Administrative Approval Action

Case File / Name: ASR-SR-29-2019
HOME2 CRABTREE SUNSET EXTENSION REVISION - 12/16/22

REQUEST: This approval is for a sunset date extension for the previously approved plans. The original plans were approved on 10/30/2019. The sunset extension request was made on 10/24/22 and the new sunset date is 10/24/24 per UDO section 10.2.8 F

AP004 1/8" = 1'-0"

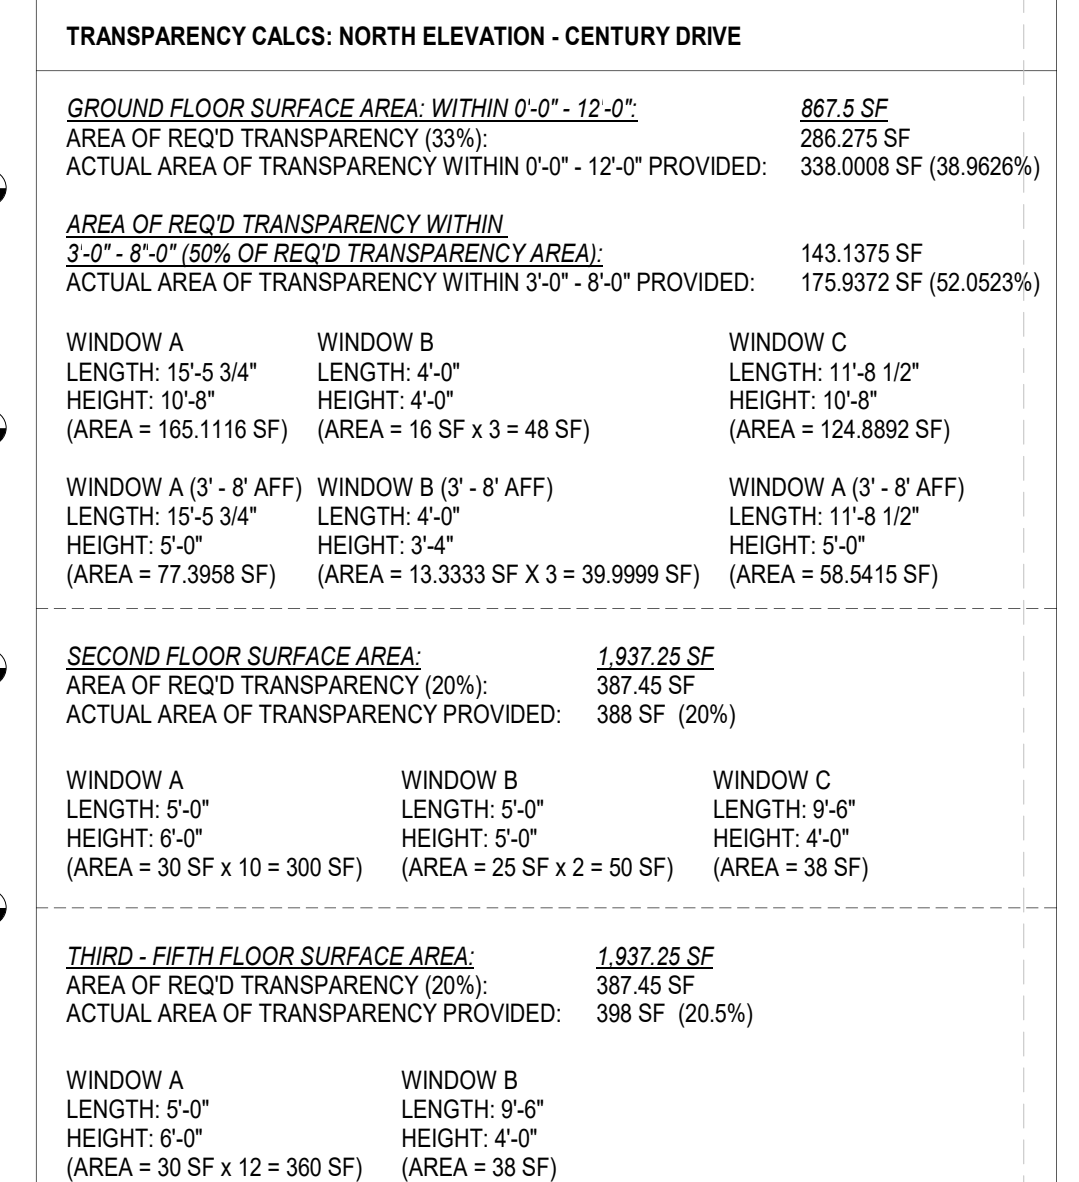
4. Conditions to A-31-19 are complied with & shown on the SPR plans (Site Permit Review).
5. The transparency table sf & calculations, for the second floor surface area, as shown on the North elevation on sheet AP004, are re-calculated & the calculation totals for the "% required" and "provided" are also revised on the SPR plans.
